Reference: *Work Plan for Additional Site Investigation*
Superior Health Linens
5005 South Packard Avenue
Cudahy, Wisconsin
BRRTS #02-41-532649
FID #241780880

Subject: Technical Assistance Superior Linens - BRRT 02-41-532649 - FID 241780880

Operations & Maintenance Plan

FIGURE 2 I
 SITE LAYOUT
 5005 SOUTH PACKARD AVENUE
 SUPERIOR HEALTH LINENS
 CUDAHY, WI

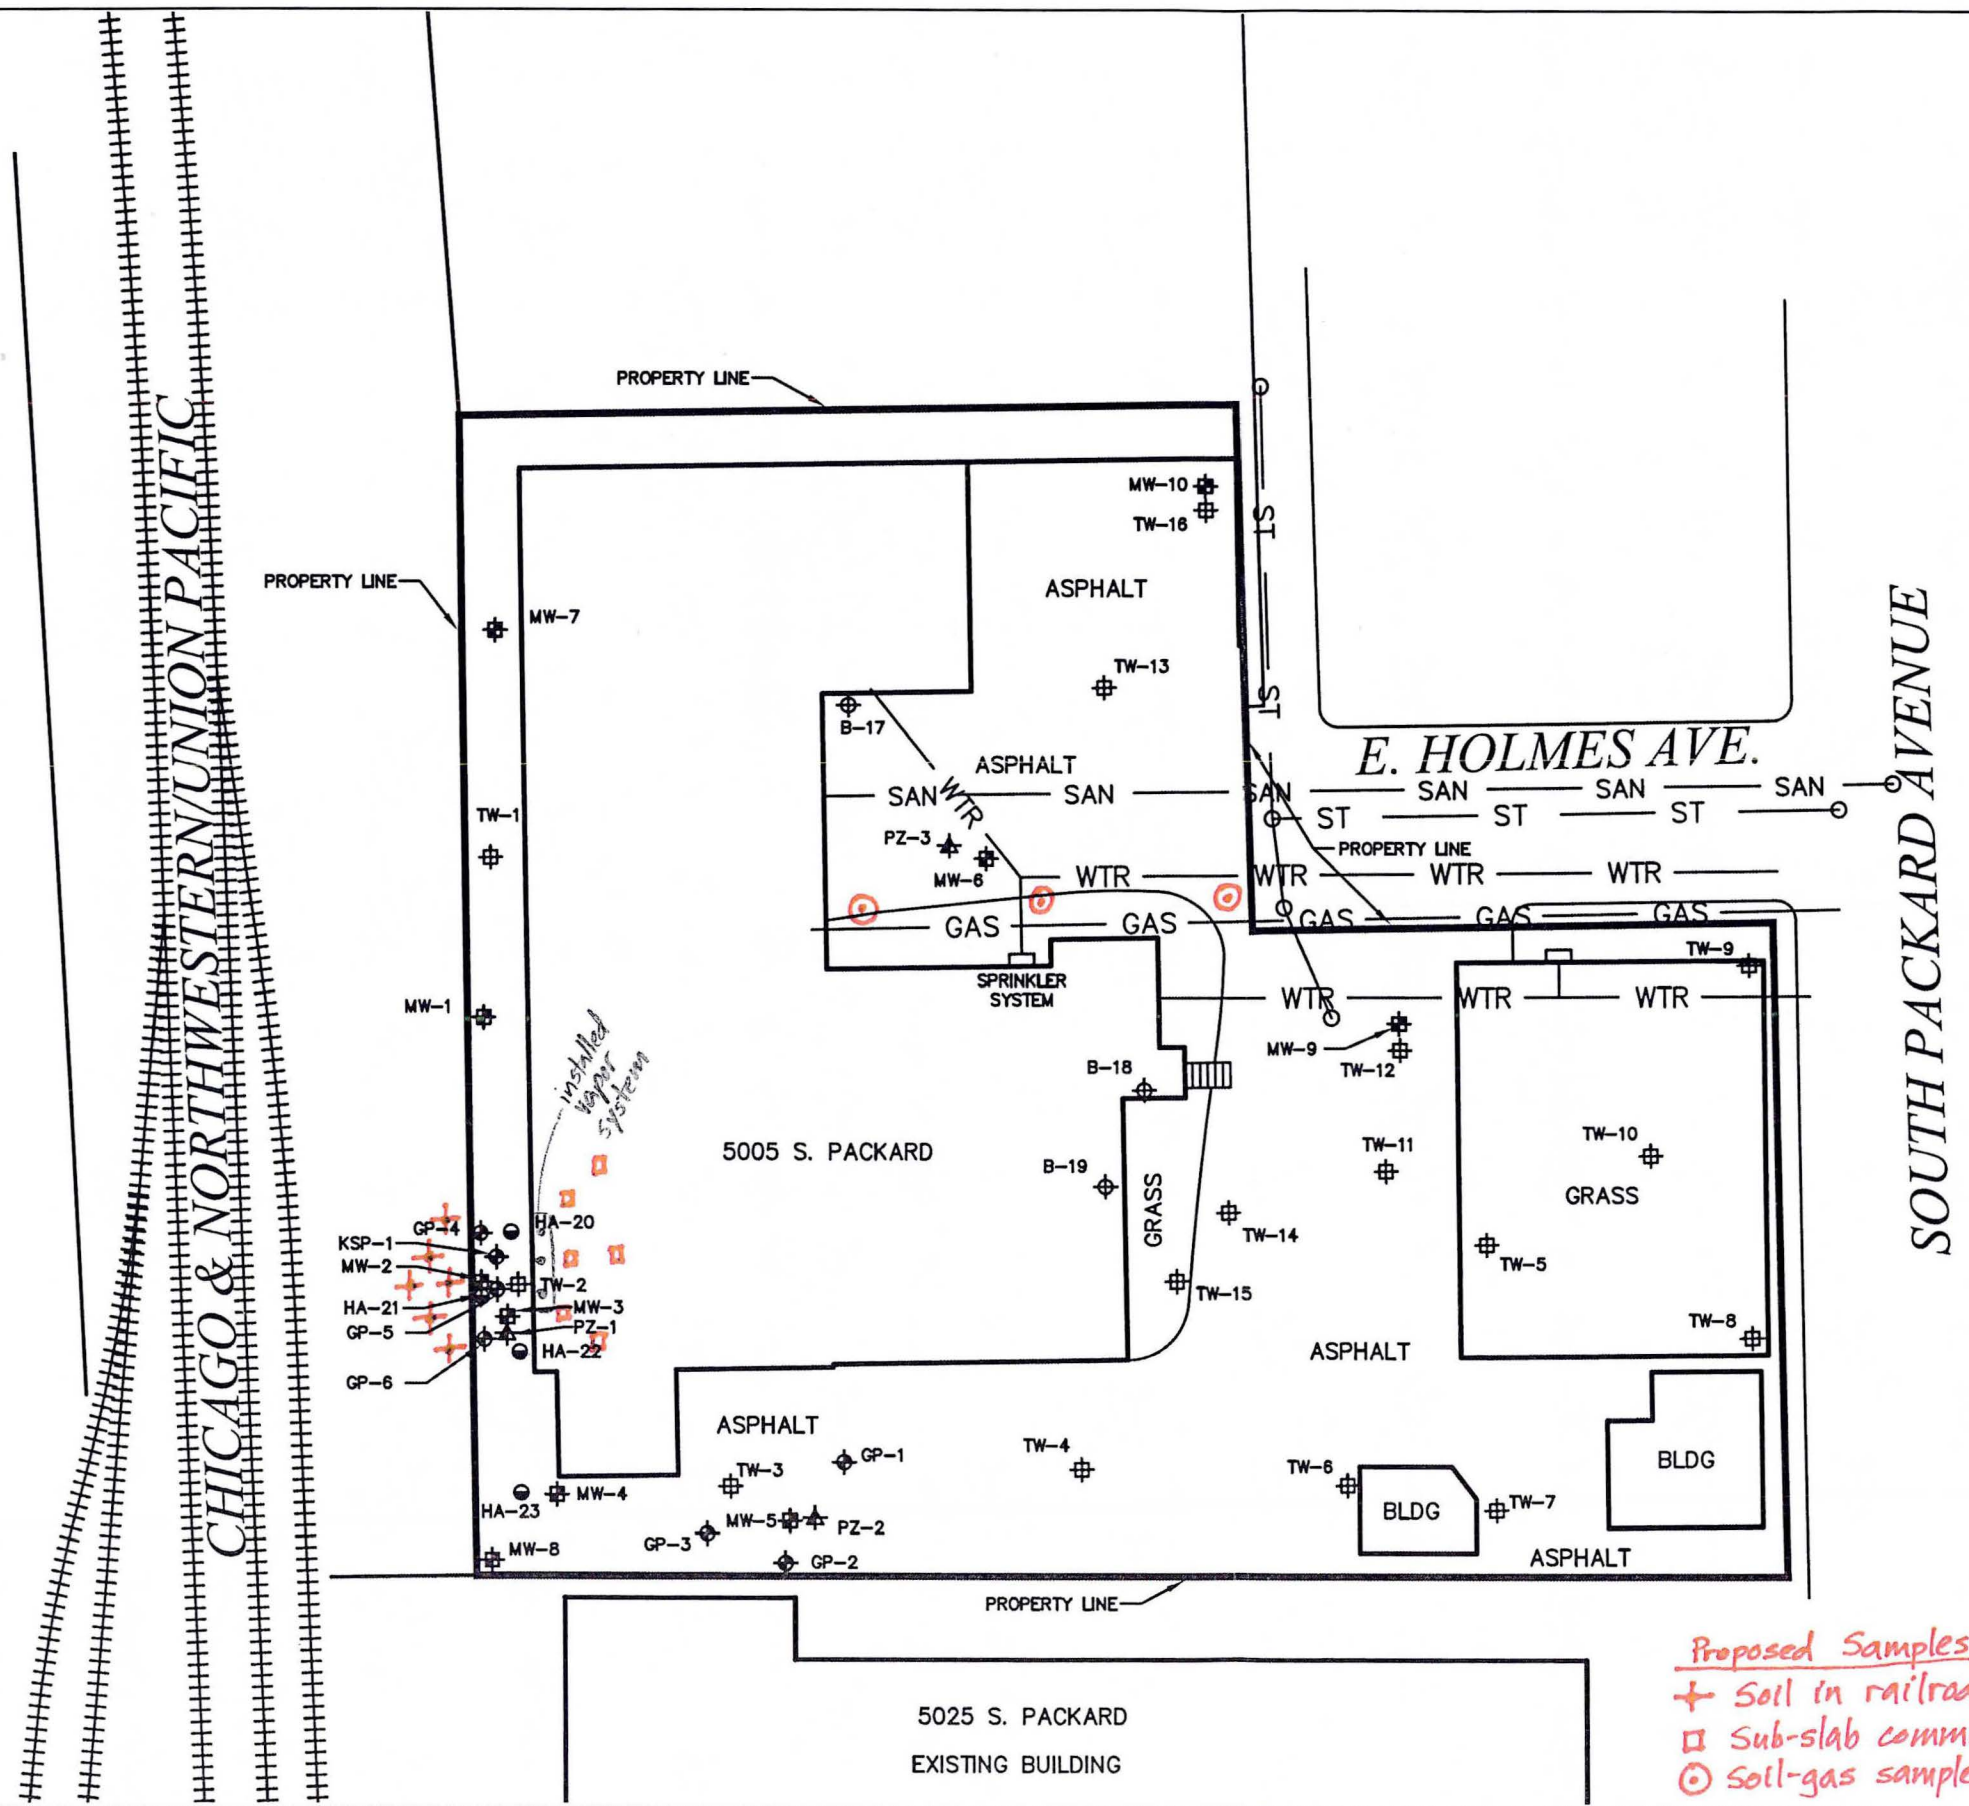
The WDNR is requesting further work to address the vertical and horizontal extent of the chlorinated volatile organic compound (CVOC) contamination that has been identified on the subject site. Refer to the Site Layout figure.

Sampling has been performed in a narrow area (approximately 22 feet in width) between the building and property line on the west side of the site. CVOC soil concentrations increase as sampling locations become closer to the property line with the Union Pacific Railroad right-of-way. This trend indicates a possible contamination source on the railroad property. KEY plans to obtain access from the railroad to collect samples by requesting an "Environmental Right of Entry". This will require completion and submittal of the following to the Union Pacific's Environmental Management Group: application form, \$555 review fee, contact information, work plan, agency directive, map(s), and monitoring well design (if applicable). The railroad requires 60 days to review the application and materials. If the request is approved, KEY will need to obtain Railroad Protective Liability Insurance before the access agreement is executed. This insurance policy is available from Marsh for a minimum fee of \$750 for 24 months.

If the railroad approves access onto its property, KEY plans to perform a survey to accurately define the property boundaries of the subject site. This will provide a reference point and allow KEY to accurately identify the sampling locations with respect to the property line. KEY will then collect shallow (< 4 feet below ground surface (bgs)) and deep (> 4 feet bgs) soil samples from the railroad property adjacent to and outward (further west, north and south) from the high CVOC concentrations detected near the subject site's property line. KEY expects to encounter groundwater and will collect groundwater samples from temporary wells. The samples will be sent to a WDNR-certified laboratory and analyzed for CVOCs.

Proposed Samples
 + Soil in railroad right-of-way
 □ Sub-slab communication testing
 ⊙ Soil-gas samples adjacent to utilities
